CITY OF WEST TORRENS

Notice of Panel Meeting

6.2.1 5 Louise Avenue, FULHAM

DEVELOPMENT NUMBER	22022380
APPLICANT	DESIGNTECH STUDIO
ADDRESS	5 Louise Avenue, Fulham
NATURE OF DEVELOPMENT	Demolish existing dwelling, two storey detached dwelling with detached rumpus room, alfresco, swimming pool and spa.
ZONING INFORMATION	<p>Zones</p> <ul style="list-style-type: none"> General Neighbourhood <p>Overlays</p> <ul style="list-style-type: none"> Airport Building Heights (Regulated) Affordable Housing Building Near Airfields Hazards (Flooding - Evidence Required) Prescribed Wells Area Regulated and Significant Tree Stormwater Management Traffic Generating Development Urban Tree Canopy <p>Technical Numeric Variations (TNVs)</p> <ul style="list-style-type: none"> Nil
LODGEMENT DATE	11 August 2022
RELEVANT AUTHORITY	Council Assessment Panel
PLANNING & DESIGN CODE VERSION	2022.14
CATEGORY OF DEVELOPMENT	Code Assessed - Performance Assessed
NOTIFICATION	Yes
REFERRALS - STATUTORY	Nil
REFERRALS - NON-STATUTORY	Nil

GROUND FLOOR PLAN

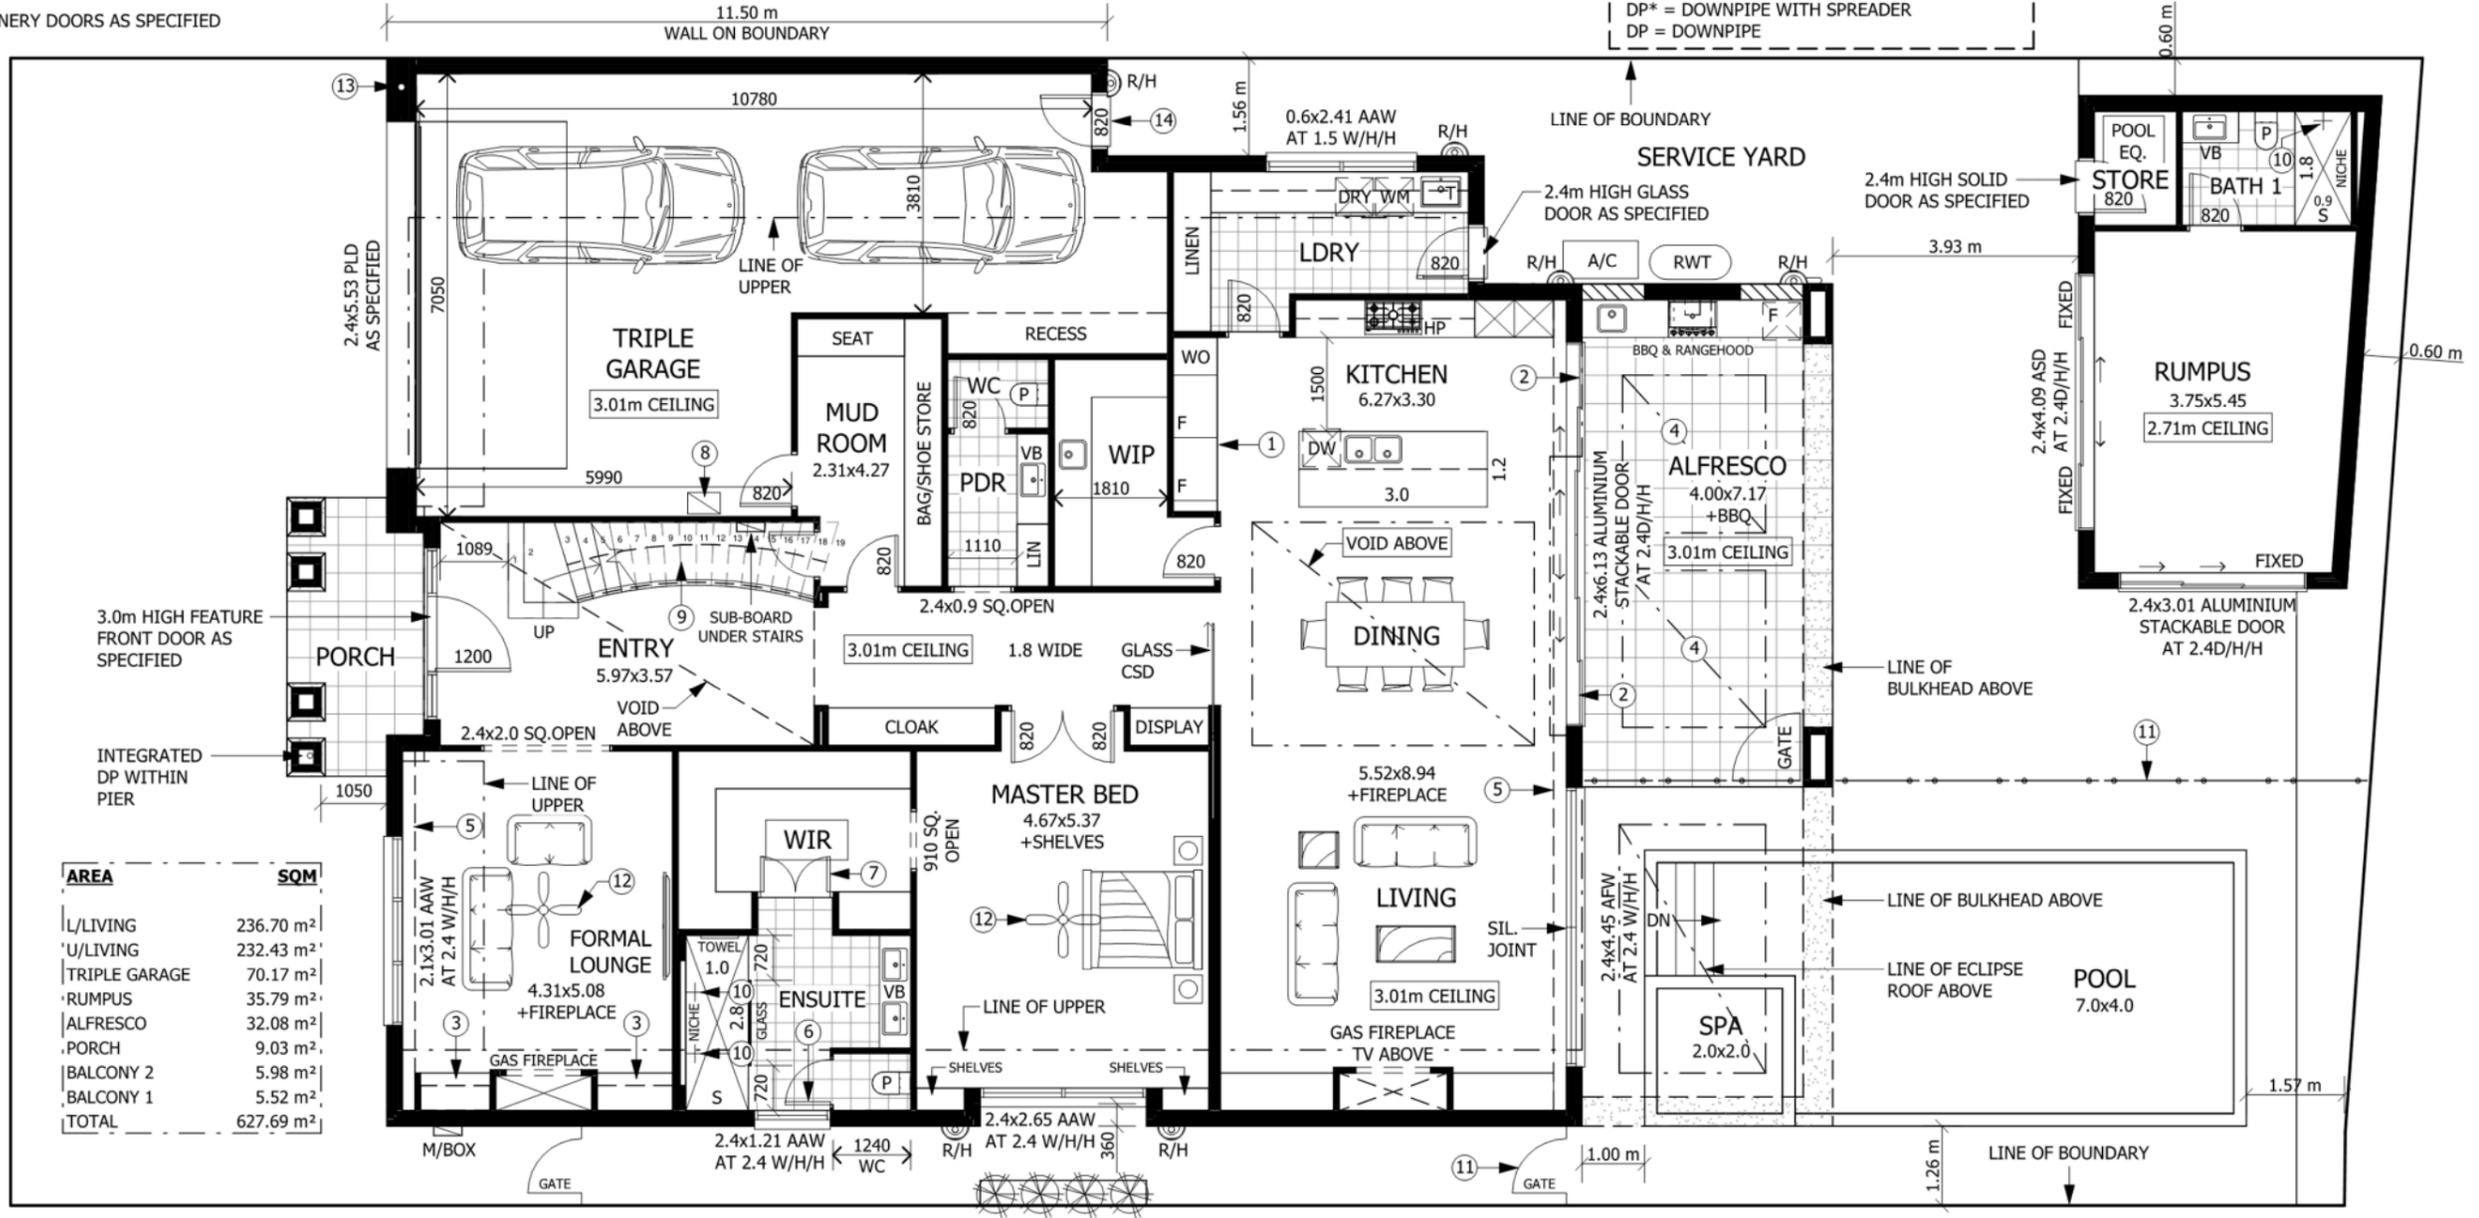
The proposed 11.5m long garage wall located on the boundary is 3.4m in height which exceeds the anticipated 3m boundary wall height identified in the Code. The additional 400mm is considered to be acceptable as it is located adjacent to a side path of the neighbouring dwelling which is not an area of primary private open space. The boundary wall is also located on the eastern property boundary of the neighbours property which will limit morning sunlight access before 10am but not after, ensuring adequate sunlight access to the neighbouring property is maintained to the Code standards discussed further in the Overshadowing section of this report. Overall, the 3.4m boundary garage wall is not considered to be a significant shortfall that outweighs other Code compliances that the development presents. Performance Outcome 7.1 contemplates boundary walls, provided they are limited in height and length to manage visual and overshadowing impacts. On balance, the development is considered to result in appropriate outcomes upon the adjoining land and the departure from the respective Deemed Performance Feature is not considered to be of a magnitude which would warrant refusal of the application.

- The Ground Floor Plan, as illustrated on Sheet 4 of 10 does not provide a dimension for the length of the wall on the boundary, which I scale at approximately 8.6 metres in length representing 46.9 per cent of the boundary.

RUMPUS ELEVATIONS

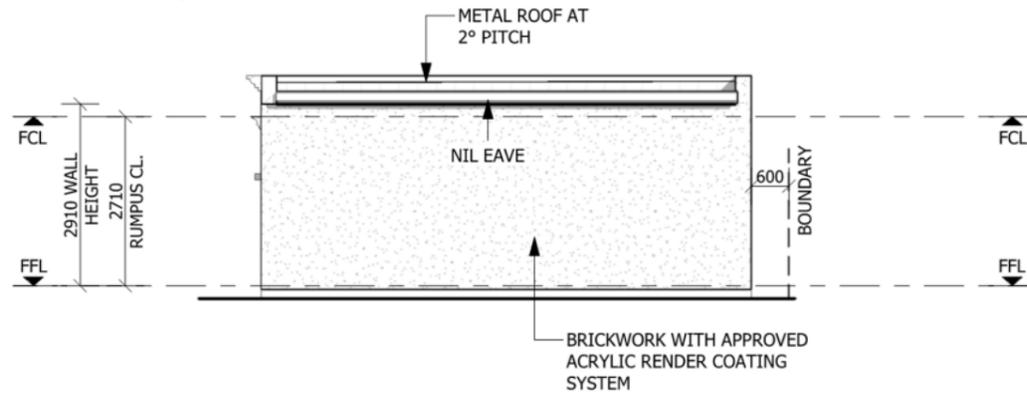
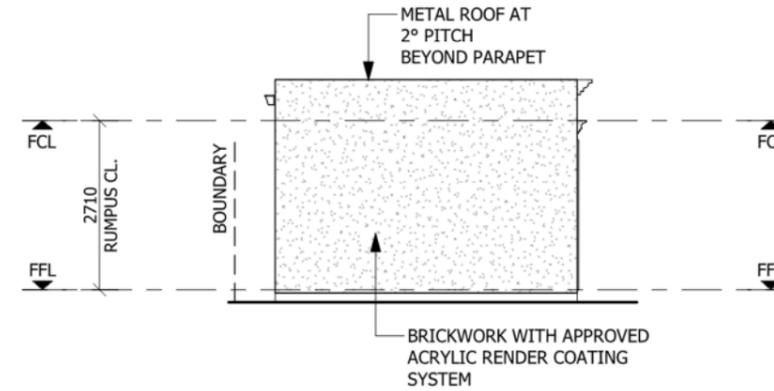
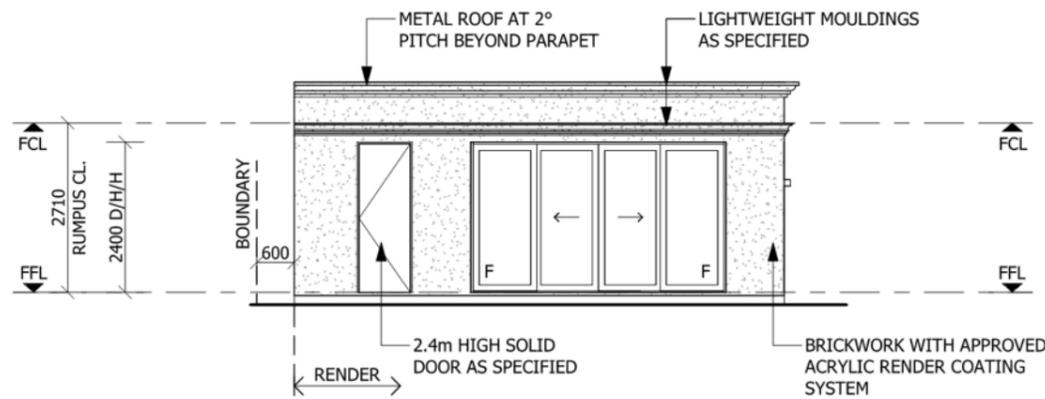
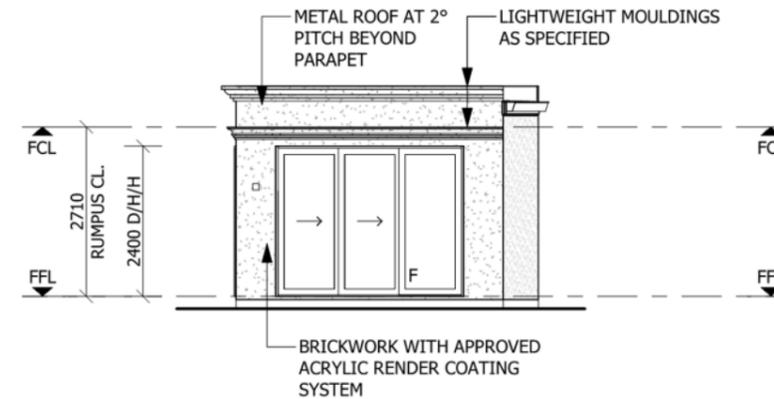
- The proposed Rumpus Elevations illustrated on Sheet 9 of 10 do not provide an overall height of the wall on the boundary, which I scale at between 3.6 and 3.7 metres in height above the finished floor level.

We also question the height of the proposed rumpus room, as it appears that the outside walls will be 3.7 metres high, notably higher than our current pool safety fence, and this will reduce our access to sunlight/warmth. These elements will impact on maintaining our eco-friendly, green environment and our personal health and well-being.

The proposed Rumpus meets the requirements of DTS/DPF 11.1 a, b (does not exceed 60m²). We have amended the drawings to reduce size of the Rumpus and moved it 600mm off side and read boundaries. The amended Landscaping Plan includes additional trees and we meet the soft landscaping requirement.

LANDSCAPING PLAN

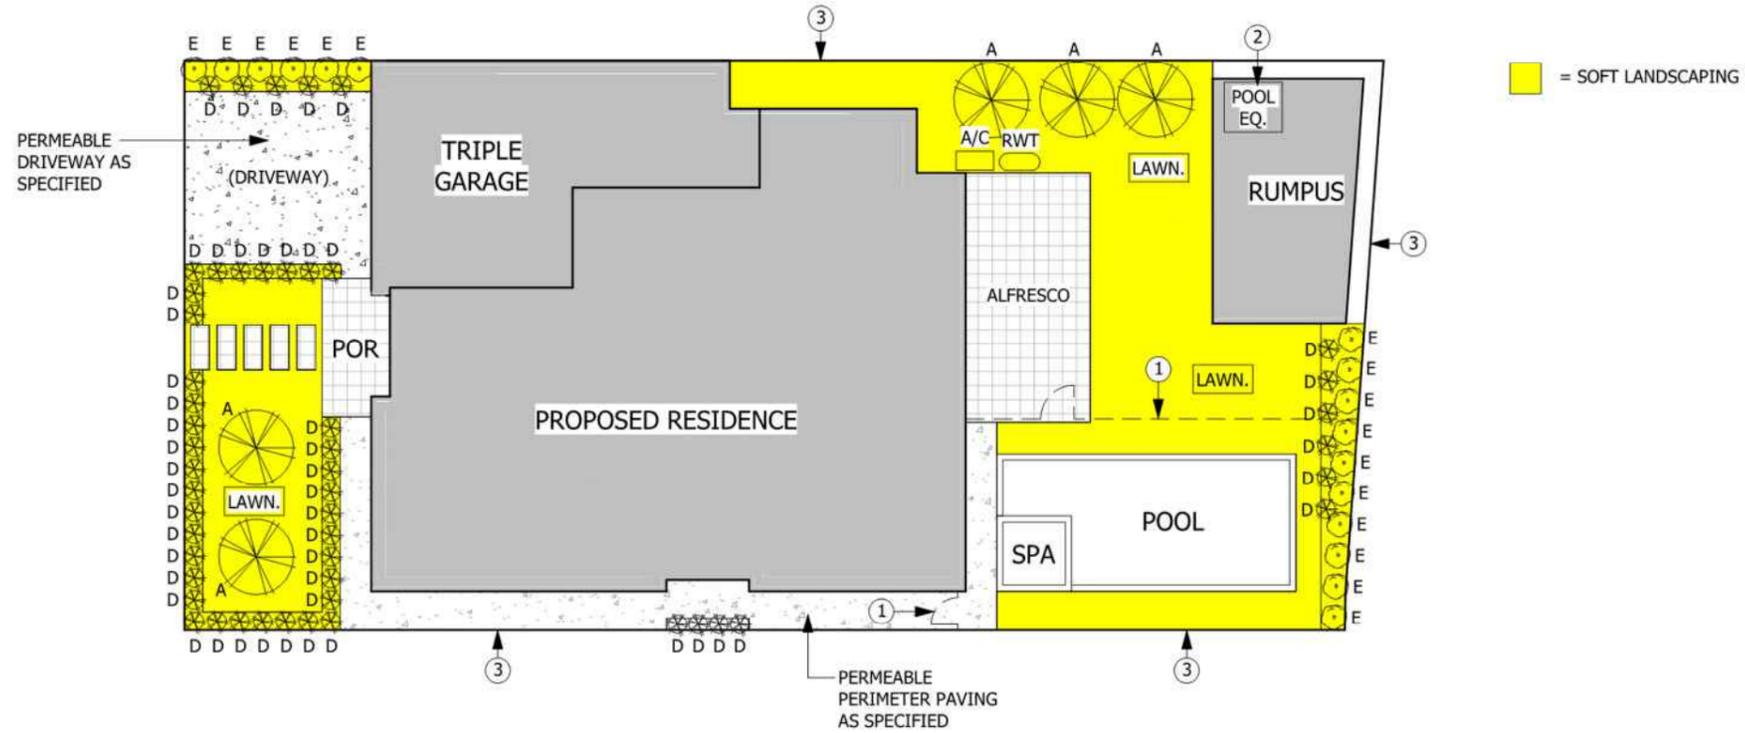
- The proposed Landscaping Plan provides for no trees to be planted in accordance with the Urban Tree Canopy Overlay applicable to the site.

- as annotated on the Landscaping Plan, Sheet 10 of 10, only 17.9 per cent soft landscaping is provided, a shortfall from the 25 per cent sought to be provided on sites greater than 450 square metres (Zone DPF 11.1(i) and Design in Urban Areas DPF 22.1). This results in a deficiency in required on-site landscaping of approximately 49 square metres, which is greater than the equivalent size of the Rumpus Room which has a floor area of 43.41 square metres; and

We understand that the proposed building is greater than 450m² and this requires a minimum of 25% area of soft landscaping. It appears that the rule about trees being planted to contribute to an urban tree canopy is not included in the proposed plans. As we know, soft landscaping has the capacity to counter act the carbon footprint that will be made on the environment.

The proposed soft landscaping has been increased following concerns raised by representors. The soft landscaping amount was previously 17.9%, well short of the 25% sought. The proposed soft landscaping is now 26.2% which exceeds 25%, satisfying the Code. The development contains a variety of landscaping species and growth heights to complement the overall built form. This includes the planting of five medium trees with growth heights up to 5 metres. The siting and location of these trees shall contribute to an outcome where the overall bulk and scale of the dwelling is minimised, while their growth height of 5 metres shall complement the two-storey nature of the building.

We have also amended the Landscaping Plan to include additional trees & to comply with the soft landscaping requirements.

Boundary fencing has been amended on the Landscaping Plan and existing fencing to be retained.

SITE PLAN
1:200

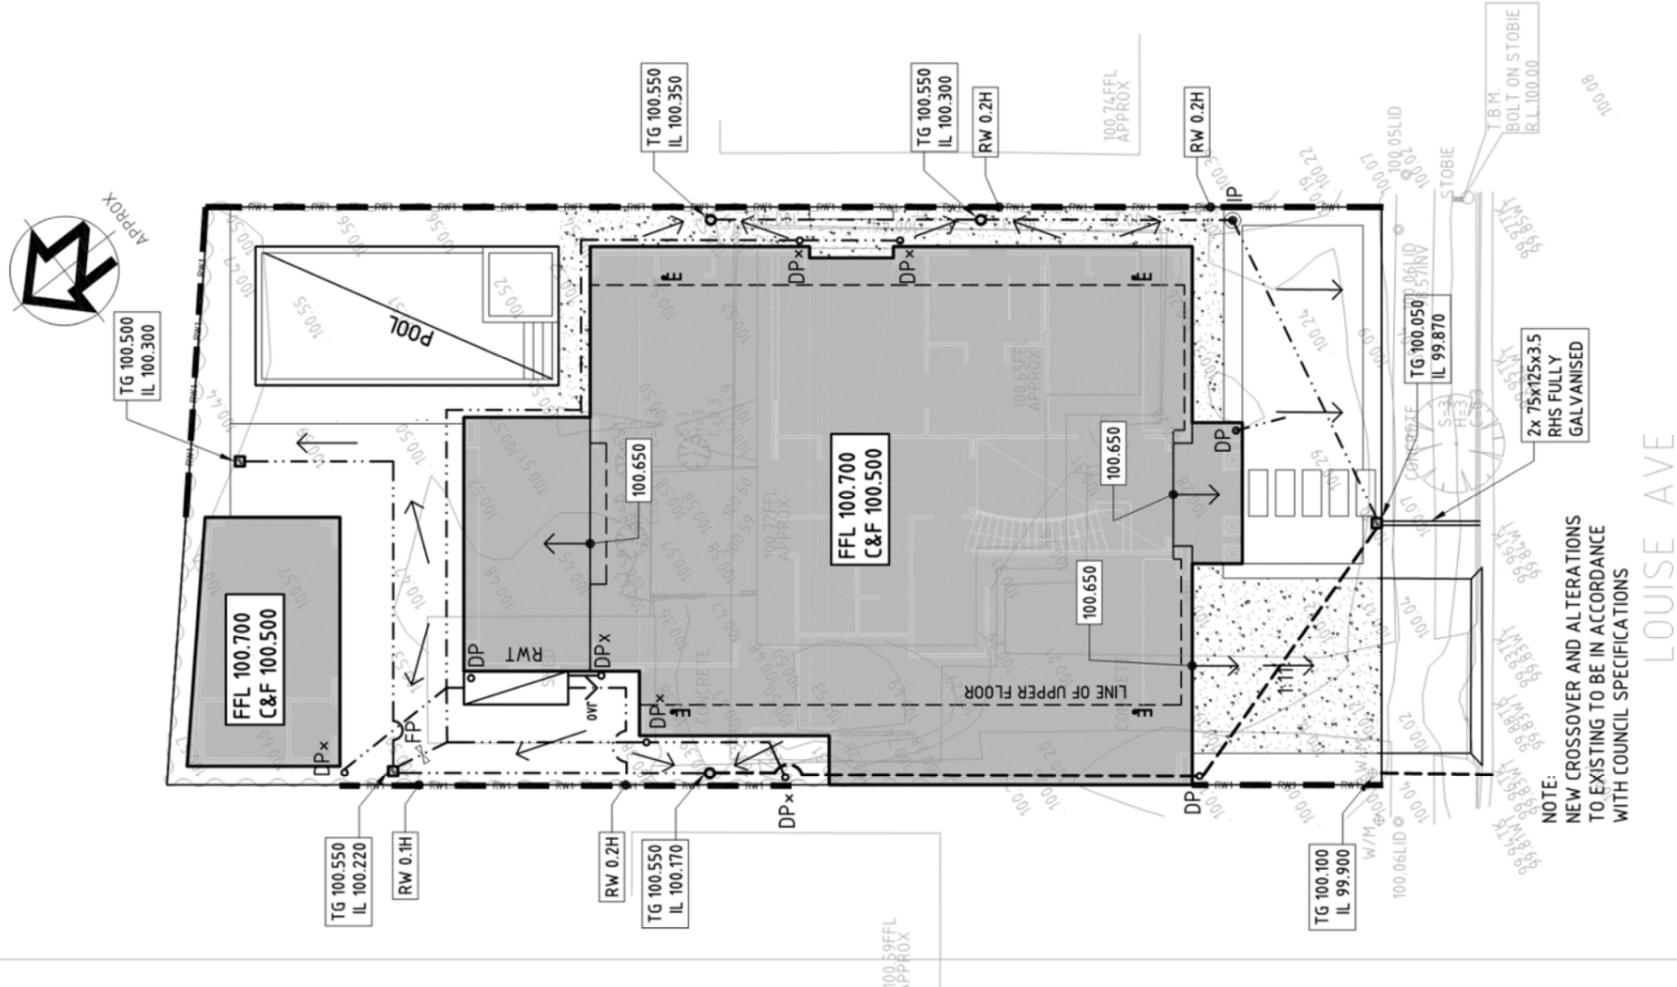
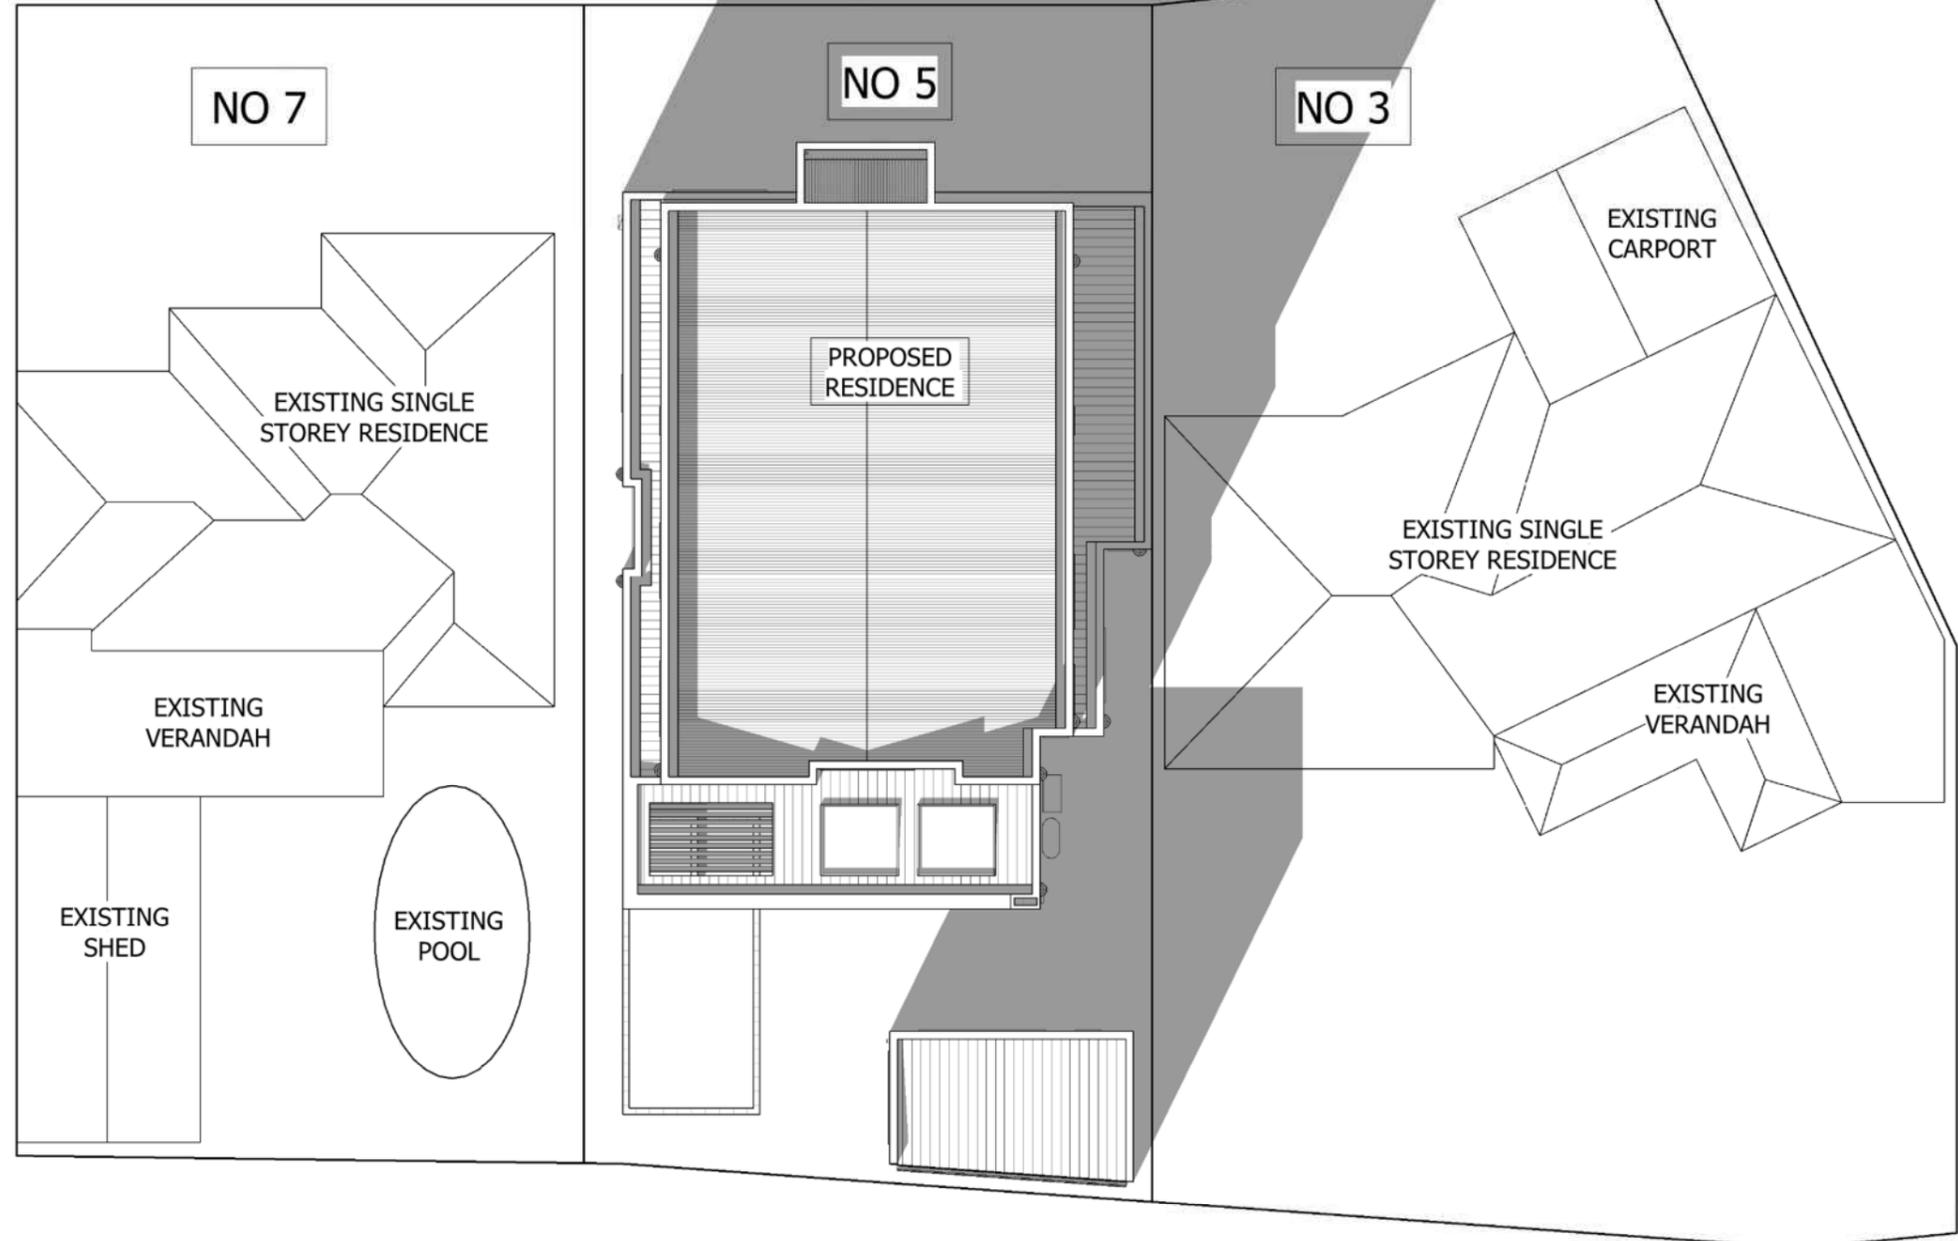
- There are no details provided with respect to whether boundary fencing is being retained or replaced albeit the Civil Site Plans prepared by Gamma Consulting, show that the site levels are to change by between 100 and 200 millimetres as reflected by the proposed retaining wall heights.
